RED BRIEF

Genie MEWP manufacturing defect

|  | Safety Notice Mandatory Action Required | 200007 | Genie A TEREX BRAND |

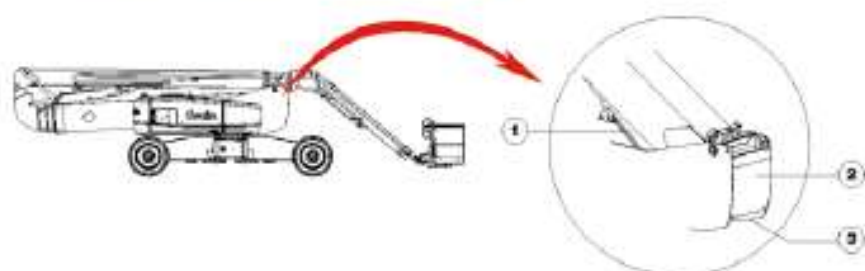
- 2 Locate the Secondary Boom Lift Cylinder.

- 1 Secondary boom lift cylinder
- 2 Upper swing cover
- 3 Lower swing cover

- 3 Locate the manifold and record the cylinder serial number stamping.

- 1 Manifold
- 2 Turntable
- 3 Cylinder Part Number (61812)
- 4 Revision Level (Rev E shown)
- 5 Cylinder Serial Number (D9E017 shown)

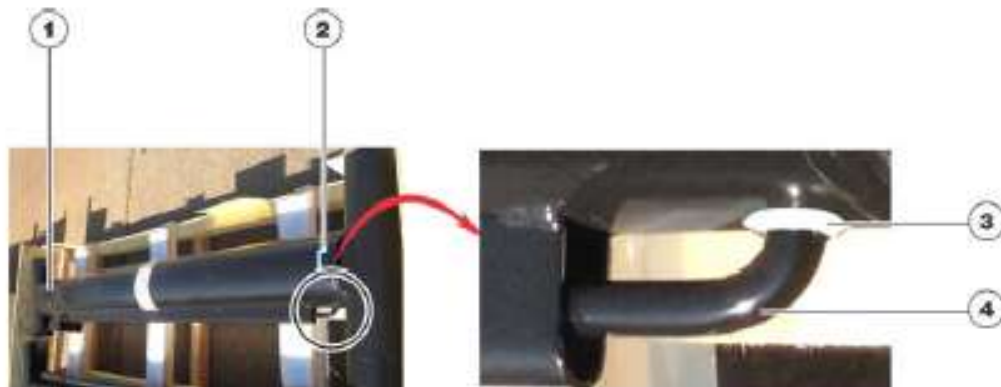
- 1 Start the engine from the ground controls and raise the secondary boom above the turntable covers.
- 2 Push in the ground controls red Emergency Stop button to the off position.
- 3 Remove the upper and lower swing covers at the pivot end of the secondary boom and set aside.
- 4 Locate the Secondary Boom Lift Cylinder.
- 5 Inspect for leaks around the weld seam between the transfer tube and the barrel as indicated below.

- 1 Manifold end
- 2 Barrel end
- 3 Weld seam
- 4 Transfer tube

⊗ **If oil leak is observed**, the cylinder needs to be replaced.

⊙ **If oil leak is not observed**, inspect for cracks in the weld seam.
